**RESPONSE TO STATEMENT OF
STEPHEN D. JENKINS
CH2M HILL, INC.
REGARDING IGCC IN THE BACT ANALYSIS FOR
THE DRY FORK STATION**

**PREPARED BY
MIKE FOWLER
TECHNOLOGY COORDINATOR, COAL TRANSITION PROJECT
CLEAN AIR TASK FORCE
BOSTON, MASSACHUSETTS**

**FOR
POWDER RIVER BASIN RESOURCES COUNCIL
SHERIDAN, WYOMING**

01 JULY 2008

Figure 2 – Generic IGCC Block Flow Diagram

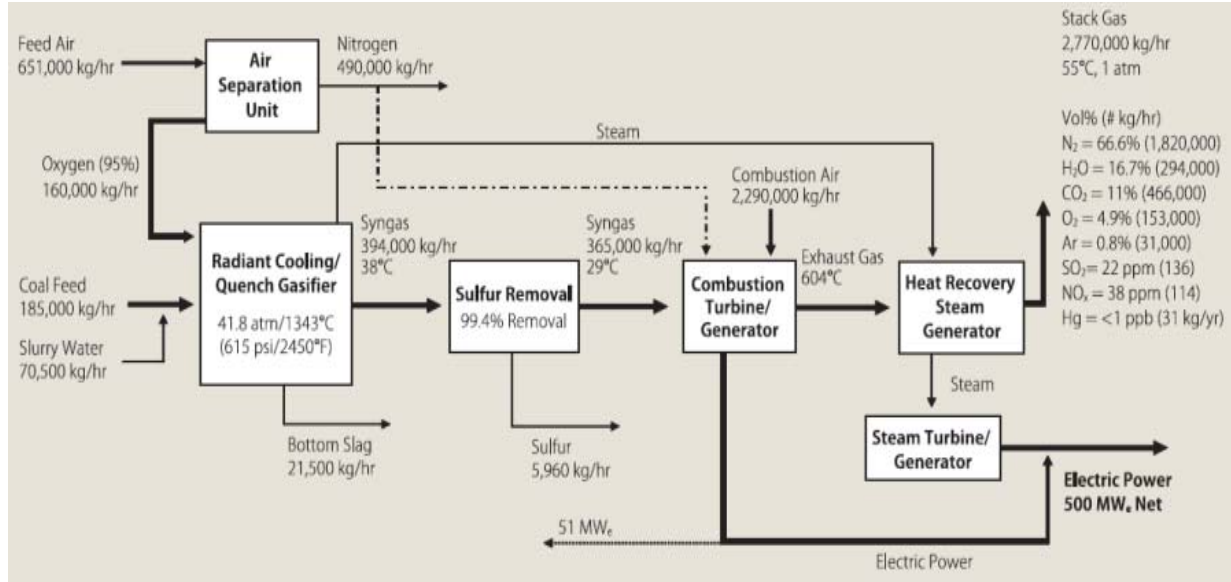
Figure 2, contained in Exhibit V, is a block flow diagram for a generic 500 MW IGCC power plant. If such a plant were operated on liquid feed instead of coal the gasifier and syngas scrubber block would change somewhat, but conceptually the rest of the plant would be largely the same. The relative size and detailed configuration of the various pieces of equipment would change, however, depending on the design feedstock.
